CITY OF CUYAHOGA FALLS, OHIO

ADDENDUM NO. 1

MUD BROOK GREENWAY TRAIL PHASE I

FORMER MUD RUN GUN CLUB
CUYAHOGA FALLS, OHIO

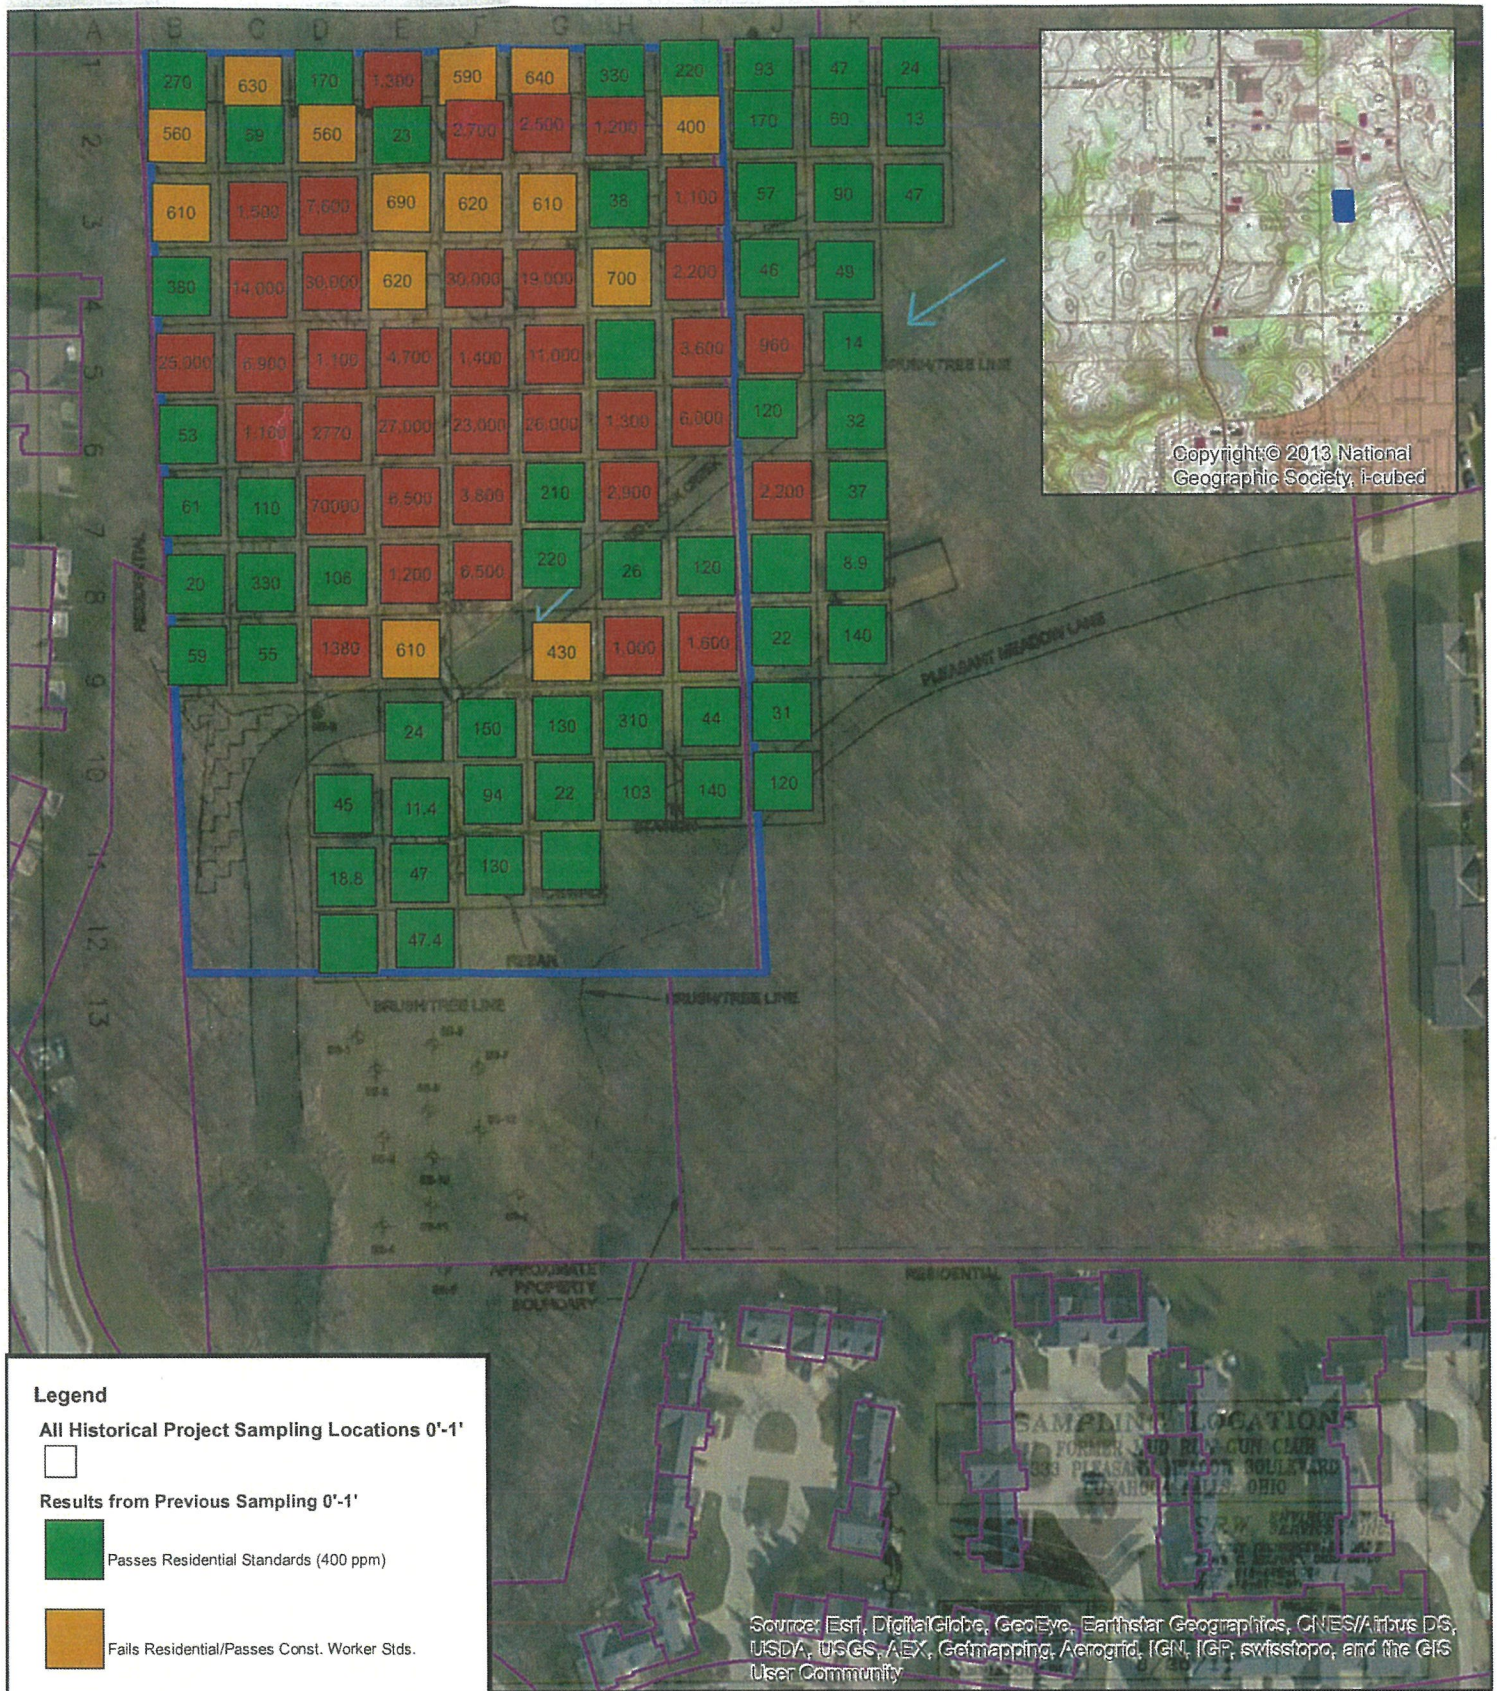
4. Can you please clarify the pay items and quantities for Item #203: Excavation and Embankment, As per Plan, 8,855 CY and Item #203: Haul Excess Soil Offsite, 7520 CY?

5. Is there any testing for the soils at the Old Gun Club?

Answer: Item #203: Excavation and Embankment, As Per Plan is described on Sheet #3 of the plan set, and shall be as per ODOT CMS 203, except soils from the excavation of the Old Gun Club (wetland/borrow pit) shall be used onsite as embankment for the trail and not hauled off site. Please see the attached map identifying the previous environmental evaluation of the Old Gun Club soils. Hauling of excess soils off site are 7560 CY.

Answer: The bid book includes information collected for the environmental investigation of the Old Gun Club. Also attached to this addendum is information about the soil's investigations, specifically including the soils area of the wetland/borrow pit, which is shaded in green.
